Safety Evaluation Report

University of Wisconsin

Docket No. 50-156

Safety Evaluation Report Related to the Renewal of
the Facility License for the TRIGA Reactor at the
University of Wisconsin

Figure 2.1 Historical Pool Water Makeup Trend

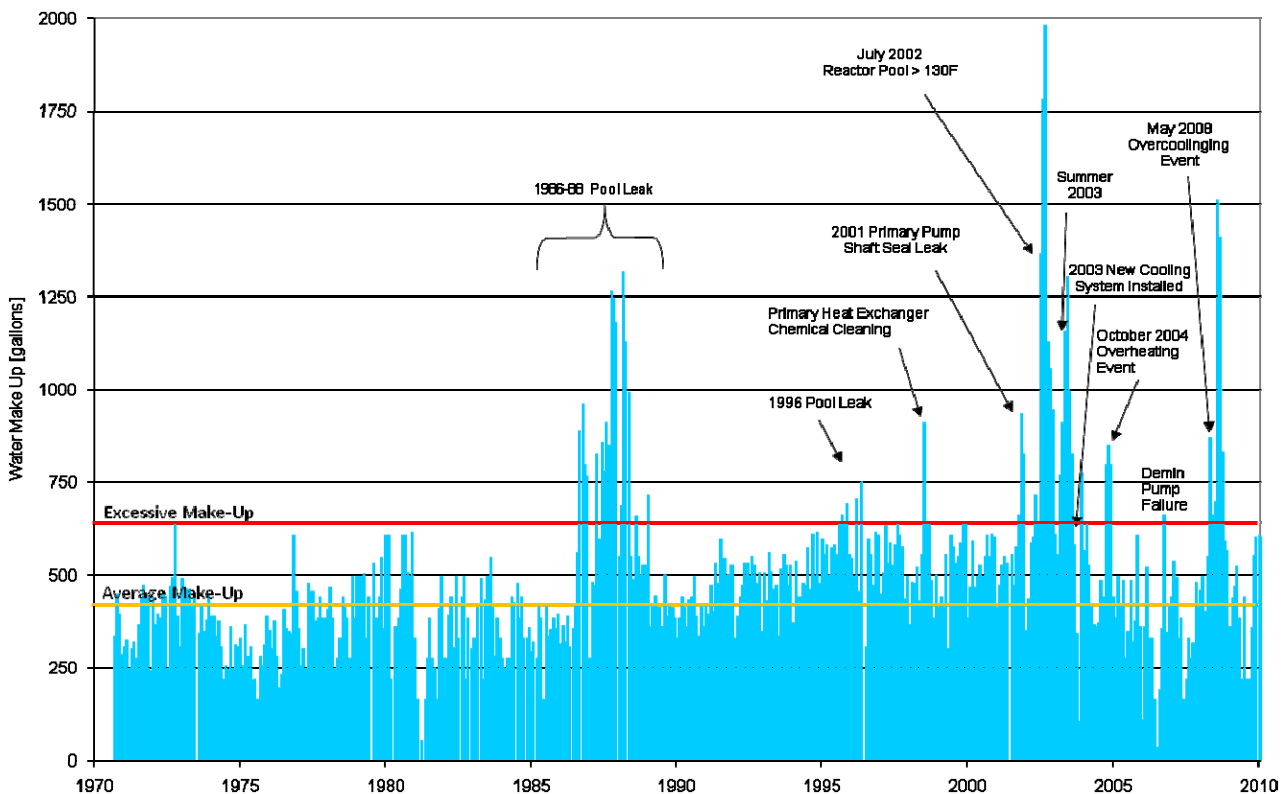
In the event that the pool leak reinitiates and an increased trend in leakage is identified, the licensee has established limits for further operation of the facility. Through the licensee response to RAI No. 1 in a letter dated June 16, 2010 (Ref 20), the licensee stated that it will adhere to the mandates of the UWNR RSC, which, in 2003, mandated a reactor shutdown and an immediate repair if either of the following conditions occurs:

- (1) pool water makeup greater than 2,200 gallons per month, or
- (2) pool water activity approaching 80 percent of 10 CFR Part 20, Appendix B, Table 2, water effluent concentration limits for isotopes with half-lives greater than 24 hours.

In the event of any further releases of pool water to the soil beneath the pool, the impact on public safety and the environment would not be significant, as the amount of water would be small and the radioactivity level would be low. As described in Chapter 11 of the 2008 SAR (Ref 9), the typical radioactivity concentrations in the primary coolant are very low. The equilibrium concentrations of predominant radionuclides in the primary coolant are within the

After reviewing the technical adequacy of the RAI response and the commitments made by the licensee, the NRC staff finds the licensee's policy and procedures on detectable pool leakage to be acceptable. The NRC staff concludes that the reactor pool will continue to perform acceptably during the license renewal period and that the licensee has the ability to detect any further leakage from the pool.

Figure -1 Organizational Chart

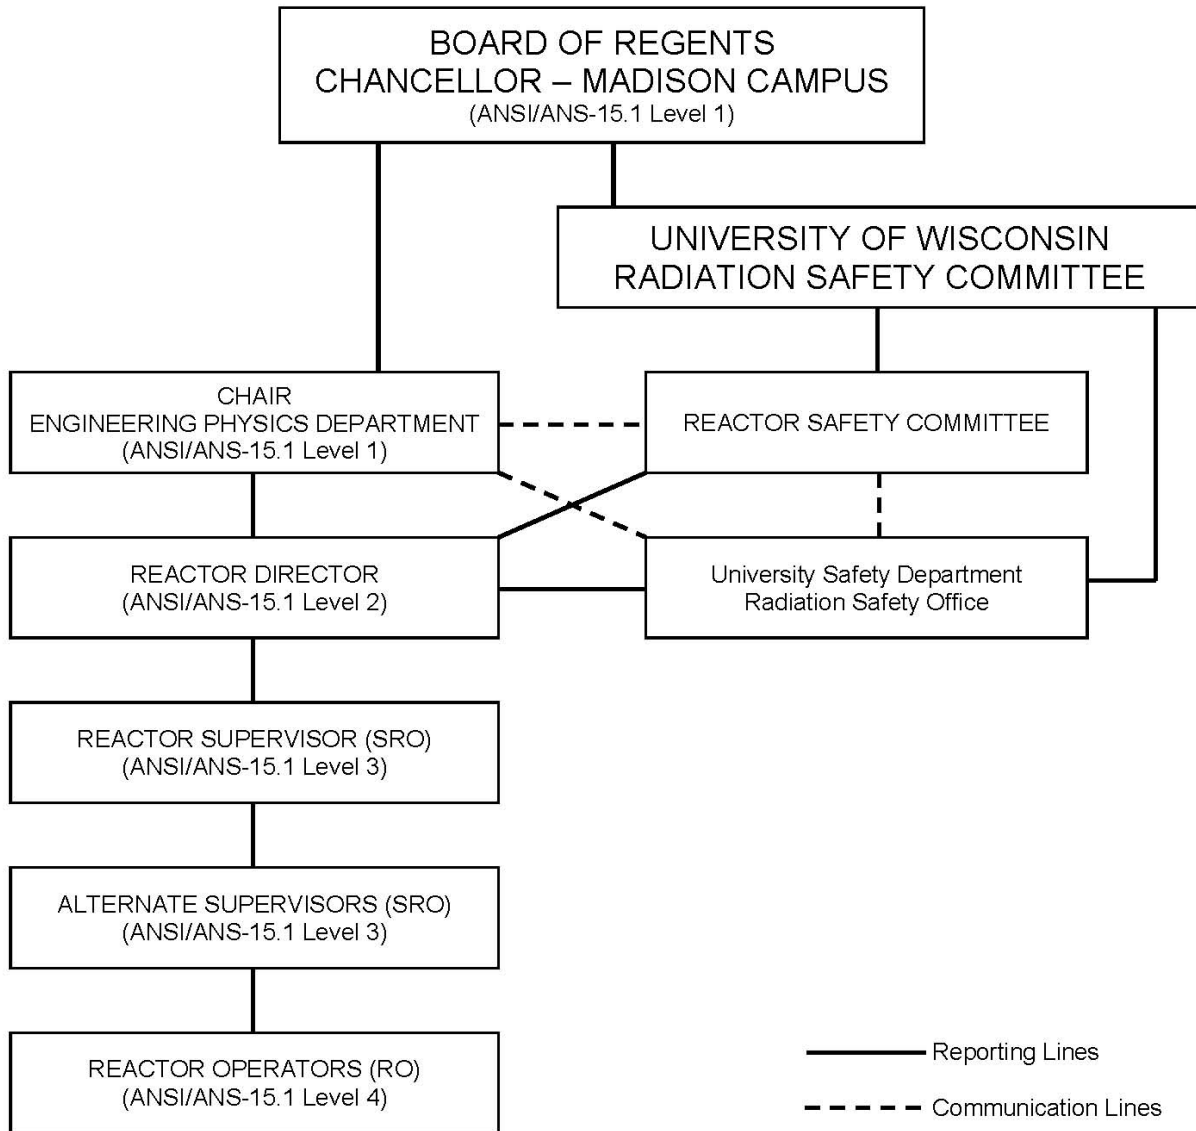
Responsibility for the safe operation of the reactor facility is vested within the chain of command shown in TS Figure -1, which depicts the licensee's organization. The organizational

responsibilities delineated in TS Figure -1 are consistent with the guidance in provided in NUREG-1537 and ANSI/ANS-15.1-2007 and are, therefore, acceptable to the NRC staff.

Certain Level 1 responsibilities of the Board of Regents of UW, the holder of the reactor license, are delegated to the Engineering Physics Department chair. The licensee revised the organizational chart (Figure -1) to reflect this clarification.
